Access Compliance Report

Public Rights-of-Way

(Curb Ramps)

Intersection ID: 10024718	Main Street: DEBORAH_DR	Cross Street: N/A	Location: N
ADA ID: 969DCFEE0A39	Ramp Type: Perp	Initial Pass/Fail: Fail	Overall Compliance: No
Severity Score: 21.25			
Codes/Mitigation Info/Possible Solution		Field Measurements/Component Compliance

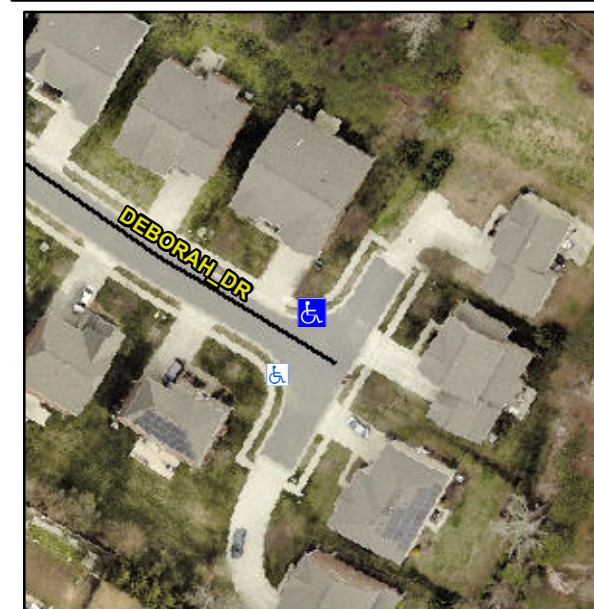
Not Found, R304.5.1, R304.2.2

Compliance	Description	Data	Compliance	Description	Data
N/A	Ramp Length (in)	48.0	No	Ramp Slope (%)	10.3
No	Ramp Width (in)	42.0	Yes	Ramp XSlope (%)	0.0
N/A	Flare Type LT	N/A	N/A	Flare Type RT	N/A
N/A	Flare Slope LT (%)	N/A	N/A	Flare Slope RT (%)	N/A
N/A	Flare Traversable LT?	N/A	N/A	Flare Traversable RT?	N/A
N/A	Landing Length (in)	N/A	N/A	DWS Provided?	N/A
N/A	Landing Width (in)	N/A	N/A	DWS Contrast?	N/A
N/A	Landing Slope (%)	N/A	N/A	DWS Length (in)	N/A
N/A	Landing X Slope (%)	N/A	N/A	DWS Full Width?	N/A
N/A	Landing Curb? (Y/N)	N/A	N/A	DWS Offset (in)	N/A
N/A	Shared Landing?	N/A			
N/A	Gutter Ponding?	N/A	N/A	Gutter Slope (%)	N/A
N/A	Gutter Lip Ht (in)	N/A	N/A	Gutter X Slope (%)	N/A
N/A	Painted X Walk1?	No	N/A	Painted X Walk2?	N/A
	X Walk 1 Direction	To SW		X Walk 2 Direction	N/A
N/A	X Walk 1 Width (in)	N/A	N/A	X Walk 2 Width (in)	N/A
	X Walk 1 Slope (%)	3.1		X Walk 2 Slope (%)	N/A
	X Walk 1 X Slope (%)	0.8		X Walk 2 X Slope (%)	N/A

Remove & Replace Entire Ramp.
